# Access Compliance Report

## Public Rights-of-Way

### (Curb Ramps)

Intersection ID: 11299	Main Street: S SUMMIT AV	Cross Street: W 4TH ST	Location: S
ADA ID: DCADB1EC0EE2	Ramp Type: PerpDiag	Initial Pass/Fail: Fail	Overall Compliance: No
		Severity Score: 17.5

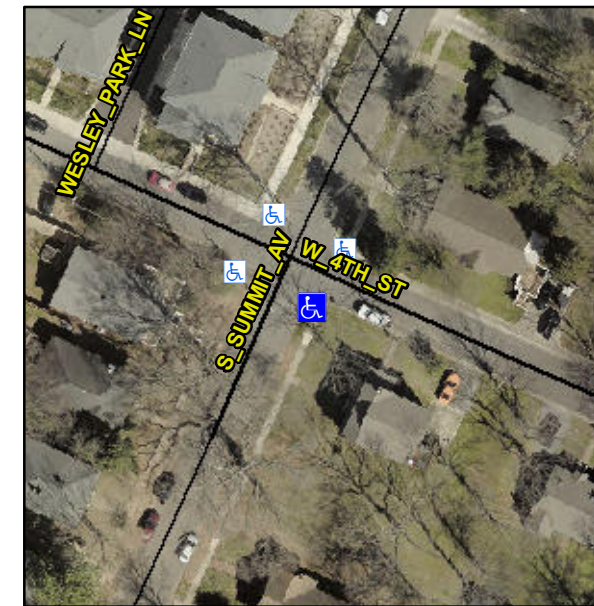
Compliance	Description	Data	Compliance	Description	Data
N/A	Ramp Length (in)	53.0	Yes	Ramp Slope (%)	5.0
No	Ramp Width (in)	34.5	Yes	Ramp XSlope (%)	1.3
N/A	Flare Type LT	N/A	N/A	Flare Type RT	N/A
N/A	Flare Slope LT (%)	N/A	N/A	Flare Slope RT (%)	N/A
N/A	Flare Traversable LT?	N/A	N/A	Flare Traversable RT?	N/A
N/A	Landing Length (in)	N/A	N/A	DWS Provided?	N/A
N/A	Landing Width (in)	N/A	N/A	DWS Contrast?	N/A
N/A	Landing Slope (%)	N/A	N/A	DWS Length (in)	N/A
N/A	Landing X Slope (%)	N/A	N/A	DWS Full Width?	N/A
N/A	Landing Curb? (Y/N)	N/A	N/A	DWS Offset (in)	N/A
N/A	Shared Landing?	N/A			
N/A	Gutter Ponding?	Yes	N/A	Gutter Slope (%)	N/A
N/A	Gutter Lip Ht (in)	N/A	N/A	Gutter X Slope (%)	N/A
N/A	Painted X Walk1?	No	N/A	Painted X Walk2?	No
	X Walk 1 Direction	To NE		X Walk 2 Direction	To NW
N/A	X Walk 1 Width (in)	N/A	N/A	X Walk 2 Width (in)	N/A
	X Walk 1 Slope (%)	1.6		X Walk 2 Slope (%)	3.3
	X Walk 1 X Slope (%)	1.8		X Walk 2 X Slope (%)	1.1

N/A	Ramp inside XWalk1?	N/A	N/A	Ramp inside XWalk2?	N/A
	Road Slope (%)	0.8	N/A	Clear Space?	N/A
	Road X Slope (%)	5.1	N/A	Clear Space to XWalk (in)	N/A
N/A	Any Obstructions?	N/A	N/A	Storm Grate/Utility Hazard?	N/A
	Obstruction Type			Storm Grate/Utility Type	
		N/A			N/A
		Yes		Surface Condition? (G/P)	Good

**Remove & Replace Curb Ramp With Two New Directional Ramps or Equivalent.**

**R304.5.1**
